ROCKY FLATS ENVIRONMENTAL TECHNOLOGY SITE ER REGULATORY CONTACT RECORD

Purpose of Contact Approval of proposed sample location offsets for IHSS Group 600-5, #IA-04-05

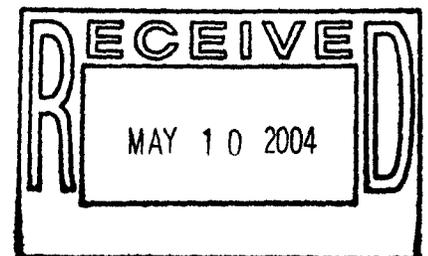
Because three sample locations in the approved SAP Addendum #IA-04-05 were located over the utility corridor along Central Avenue Ditch the following relocations were proposed

- BZ39-034 (biased location) relocate 6 feet south of location in approved SAP (this location did not target a specific release, was intended for additional sampling coverage only),
- CA39-016 (statistical location) relocate 8 5 feet south of proposed location in approved SAP, and
- CB39-008 (statistical location) relocate 3 5 feet south of proposed location in approved SAP

Mr Ainscough agreed, via e-mail, that the offsets were appropriate and approved of the proposed relocations The sample offsets will be explained in the discrepancy table in the data summary or closeout report
